File: 04-SF-1/101
Doyle Dr. Project Contract 3
04-163733

Subject: Request for Contract Change Order

This is to initiate a Contract Change Order request for replacing the light pedestal, VMS sign, construction signs to accommodate the Presidio Trust request and recommendation. (Please check all applicable boxes):

Brief Description of Work: Brief Description
Replacing the standard light poles and VMS signs to a new custom design.
This Contract Change Order is necessary due to the following: Why Change?
To accommodate the Presidio Trust request. Construction will resolve any cost related issue created by this CCO with the contractor in the field.

TWO POST VARIABLE MESSAGE SIGN AND PEDESTAL

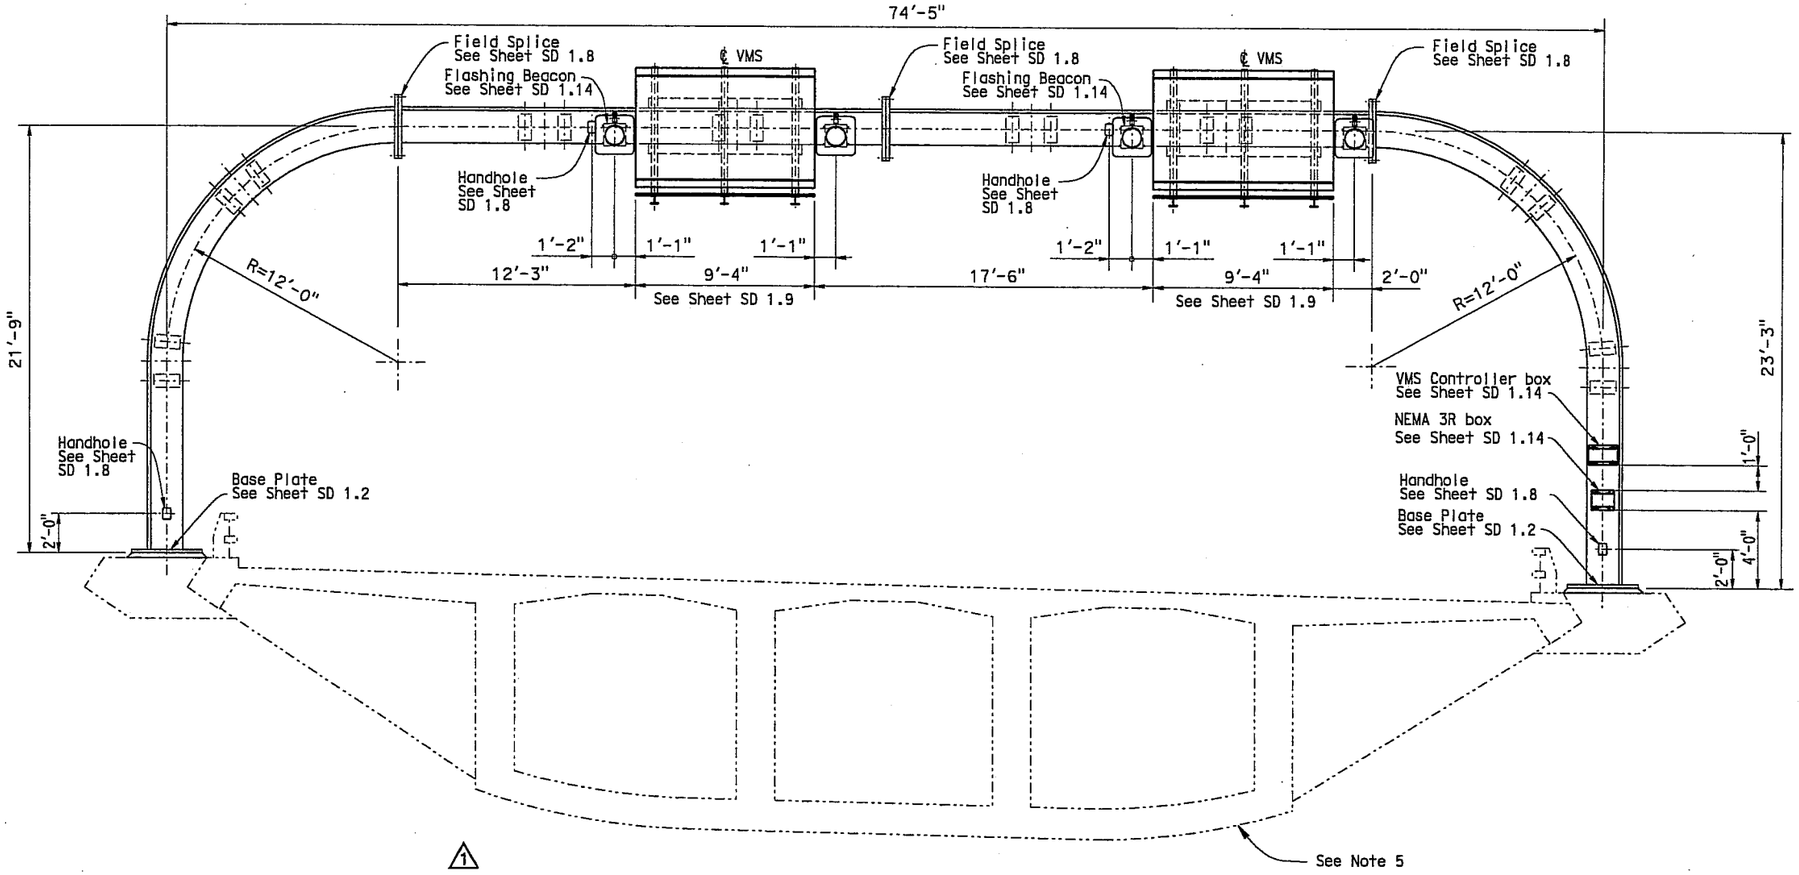
MARK	DATE	REVISION(S) DESCRIPTIONS	DES	CHK	DET
2	3-10-10	Added GENERAL NOTES	LM		AD
1	3-10-10	Revised Details and Notes	LM		AD

PRESIDIO VIADUCT - LEFT
PEDESTAL DETAILS NO. 2

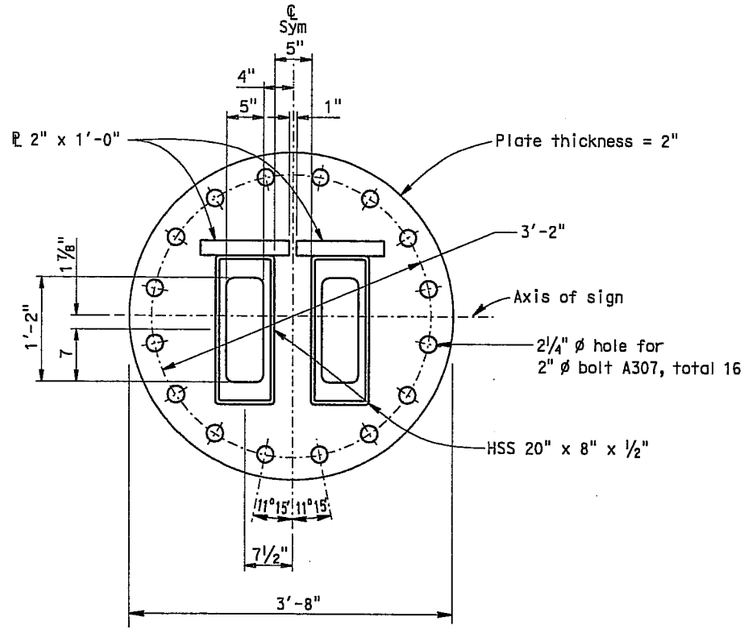
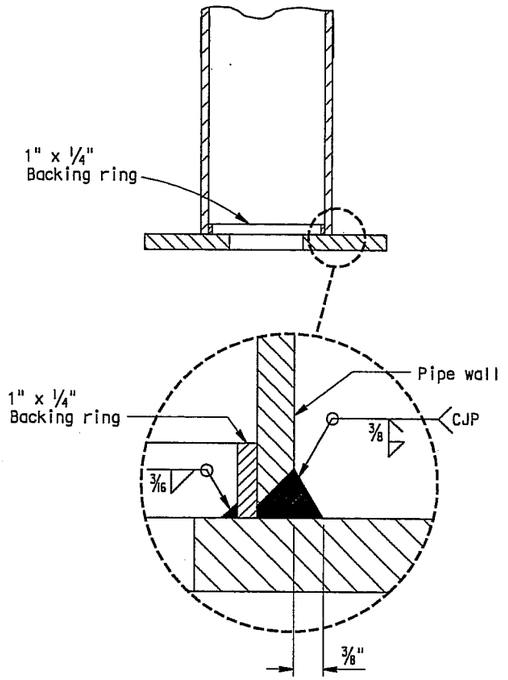
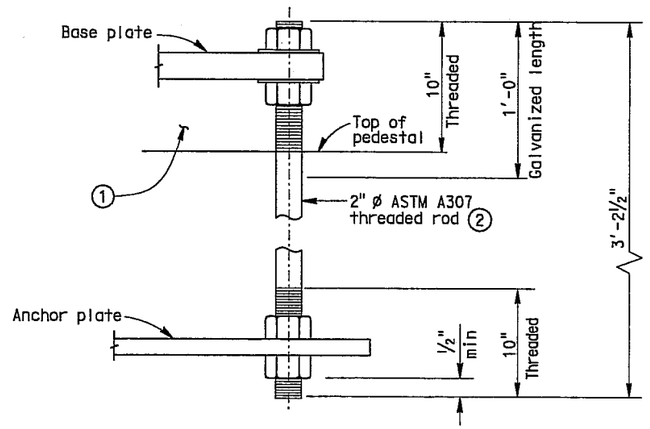
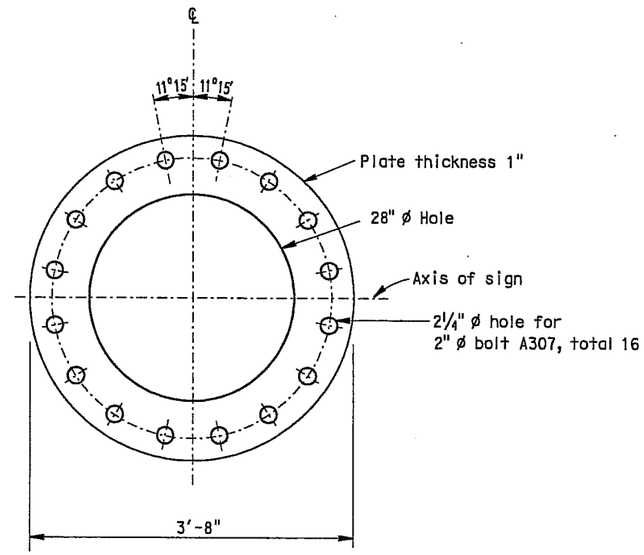
MARK	DATE	REVISION(S) DESCRIPTIONS	DES	CHK	DET
1	3-10-10	Revised Entire sheet	RB		DJ

PLAN VIEW 1

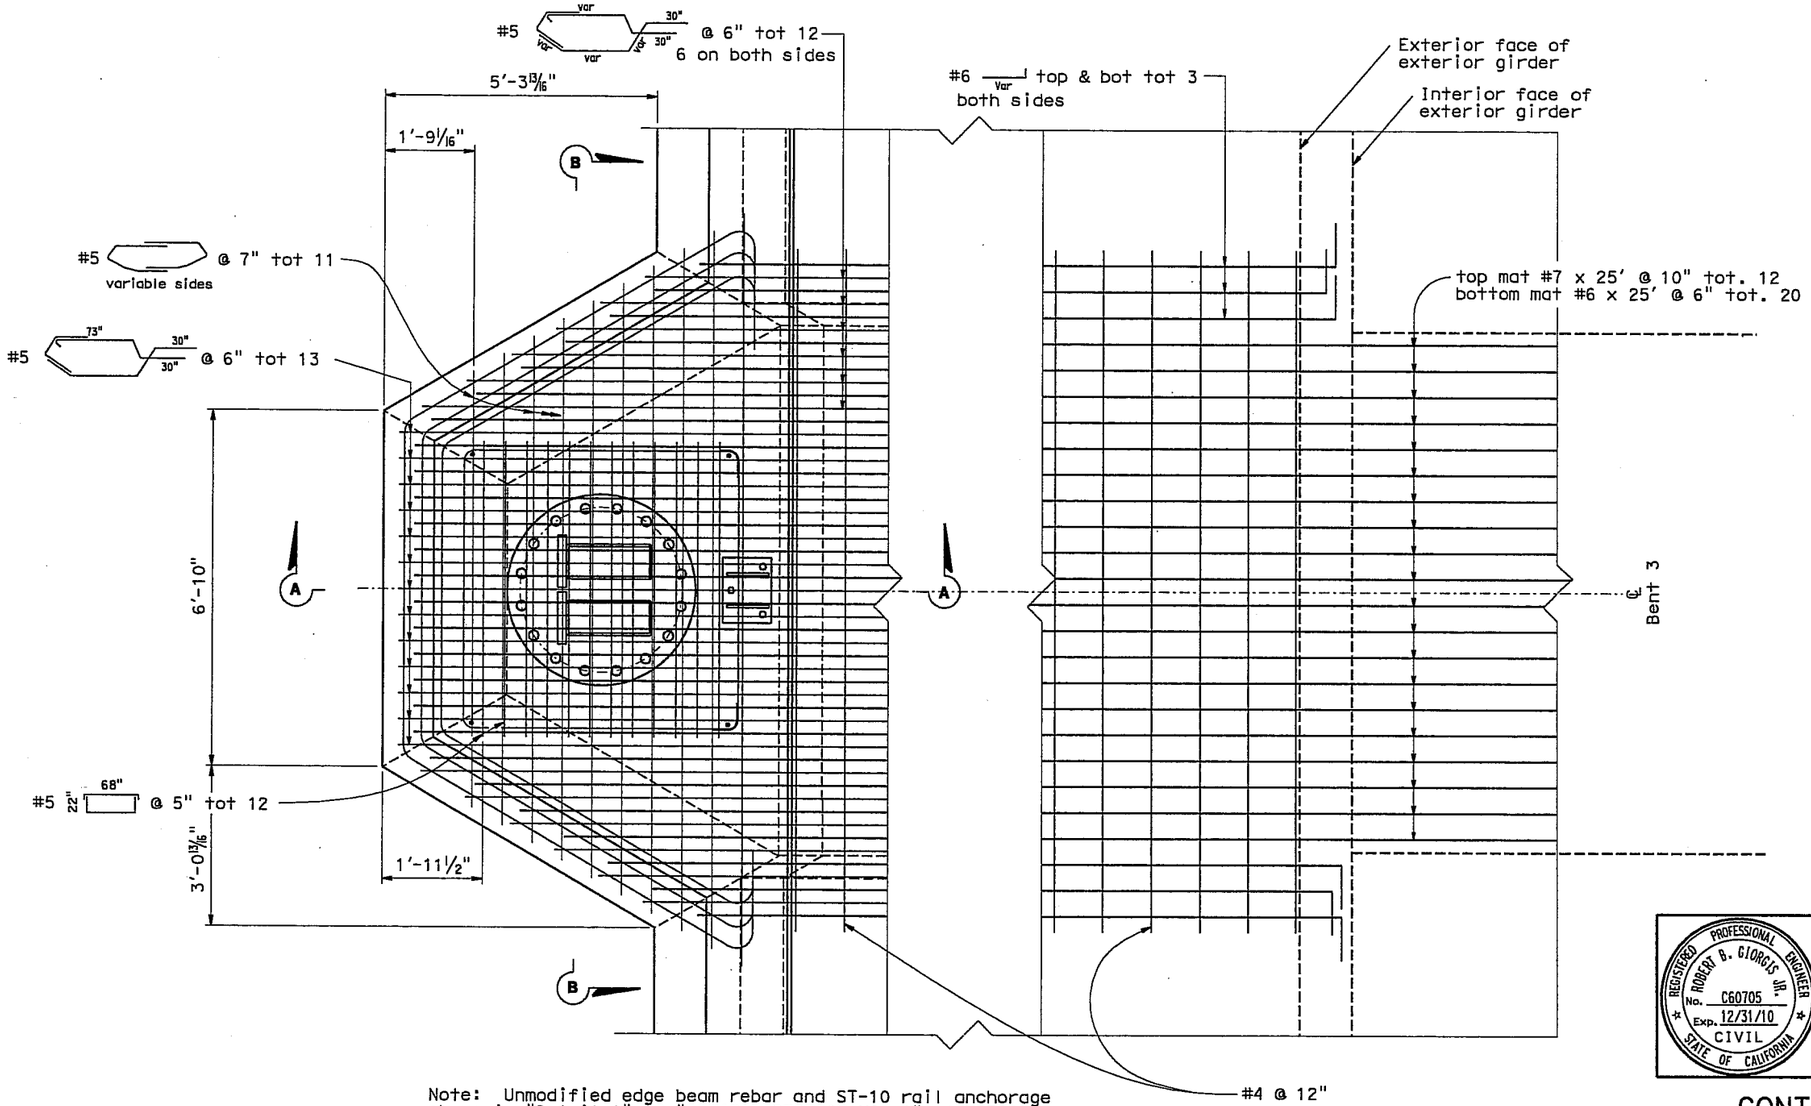
MARK	DATE	REVISION(S) DESCRIPTIONS	DES	CHK	DET
1	3-10-10	Revised Plan View and Notes	RB		DJ
REGISTERED CIVIL ENGINEER:			DATE: 3-10-10

VIEW A-A

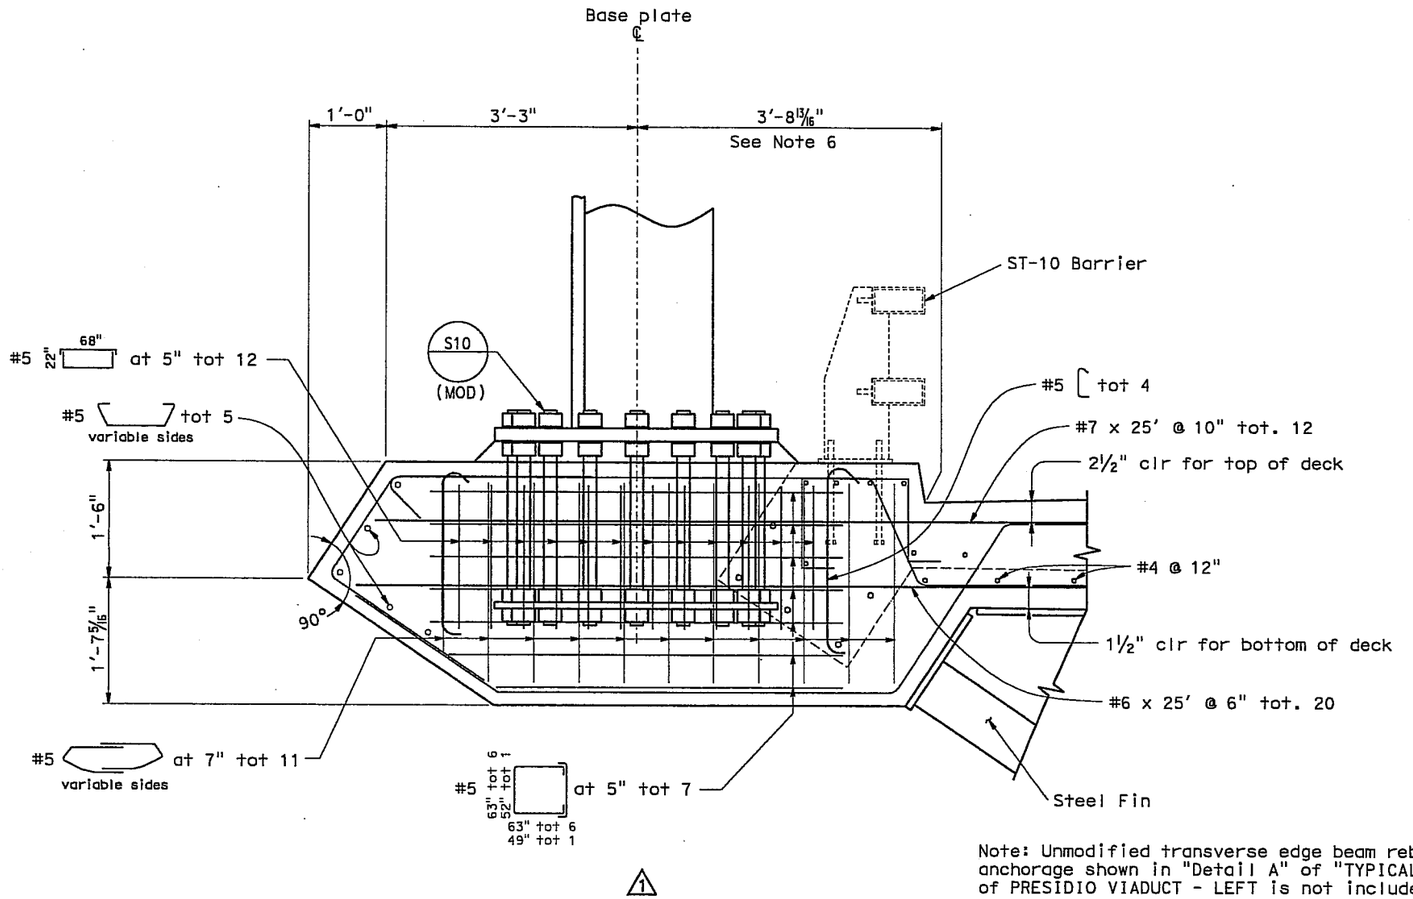
MARK	DATE	REVISION(S) DESCRIPTIONS	DES	CHK	DET
1	3-10-10	Revised View A-A and Notes	RB		DJ

VIEW B-B

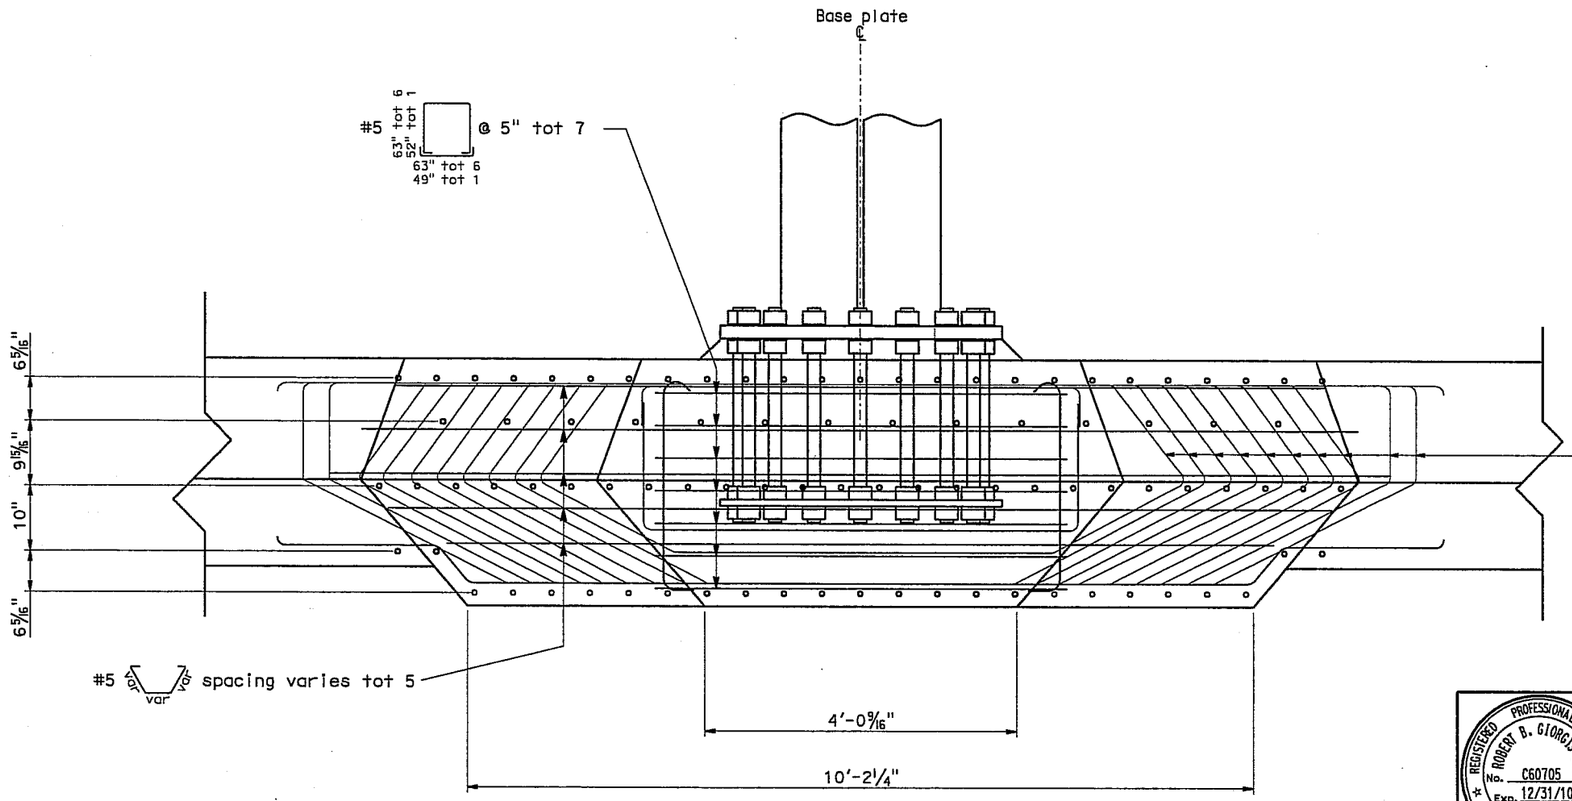
MARK	DATE	REVISION(S) DESCRIPTIONS	DES	CHK	DET
1	3-10-10	Revised View B-B and Notes	RB		DJ

FIN MODIFICATION TO ACCOMMODATE DROP SLAB DETAIL

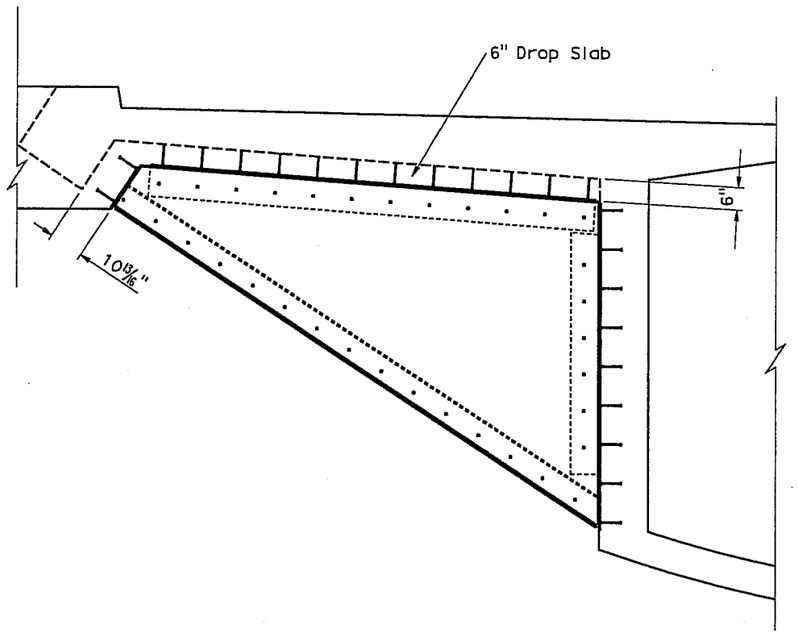
MARK	DATE	REVISION(S) DESCRIPTIONS	DES	CHK	DET
1	3-10-10	Revised Entire sheet	RB		DJ

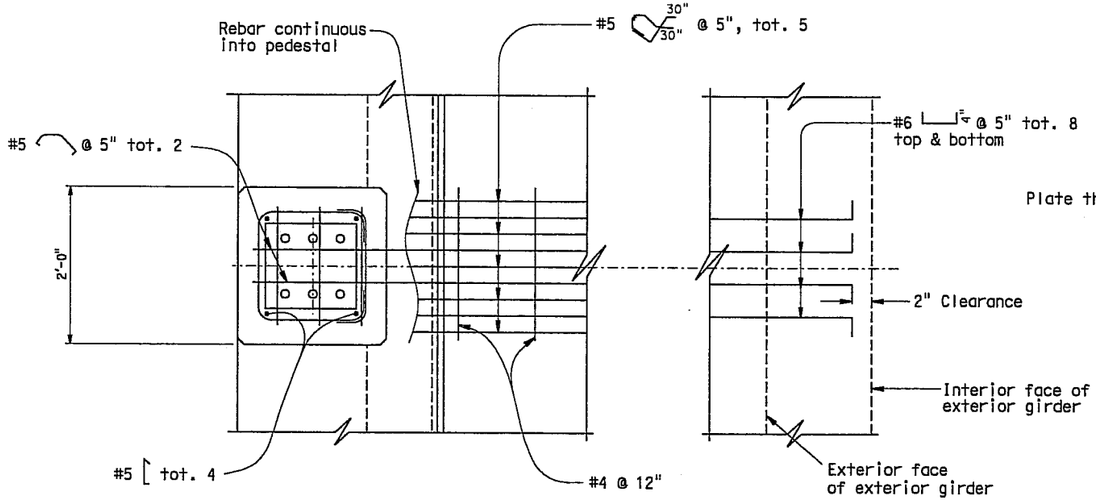
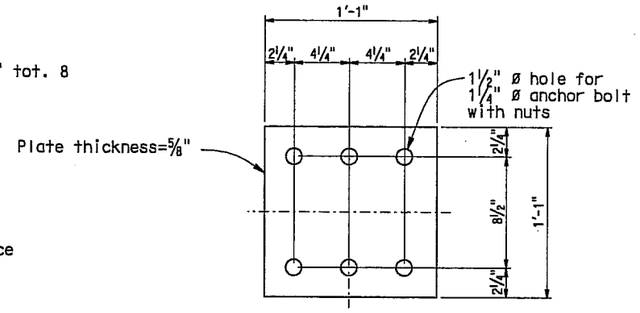
MARK	DATE	REVISION(S) DESCRIPTIONS	DES	CHK	DET
1	3-10-10	Revised Entire sheet	RB		DJ

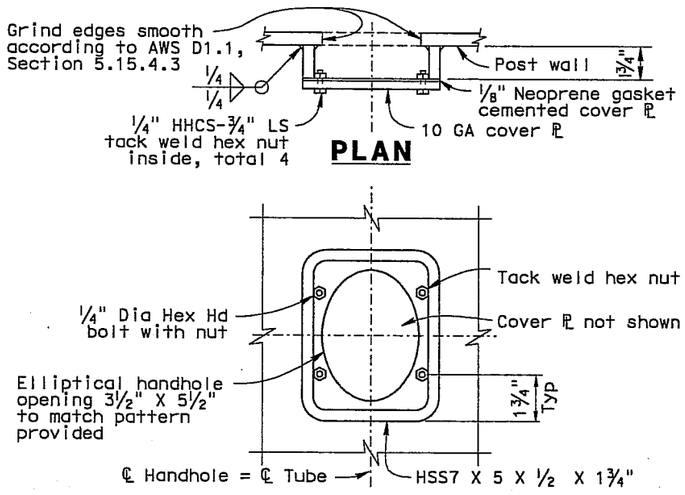
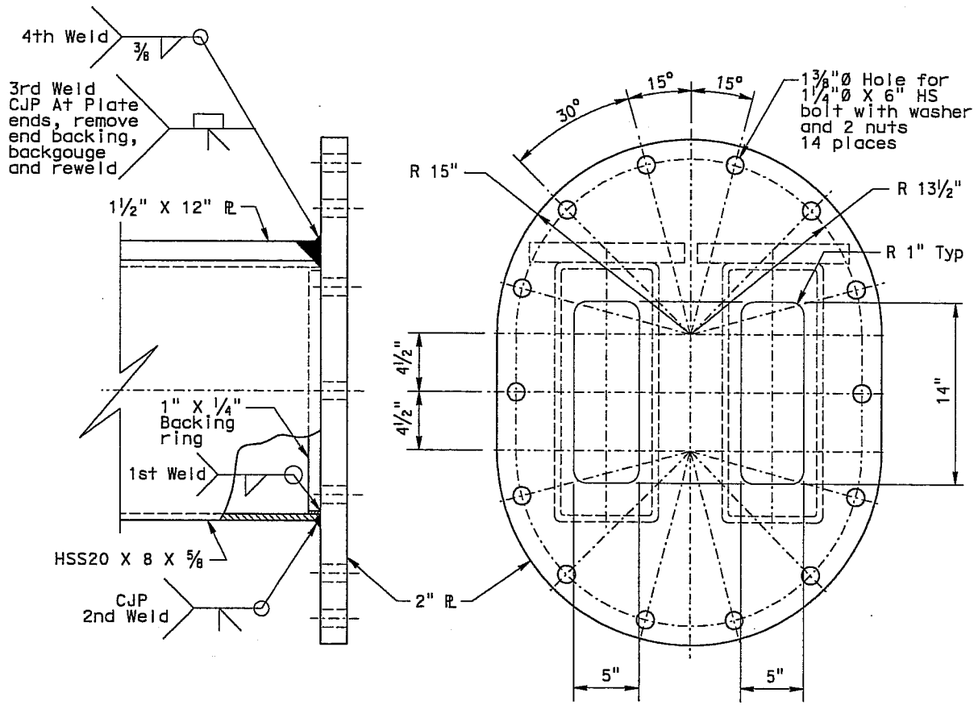
MARK	DATE	REVISION(S) DESCRIPTIONS	DES	CHK	DET
1	3-10-10	Revised entire sheet	LM		AD
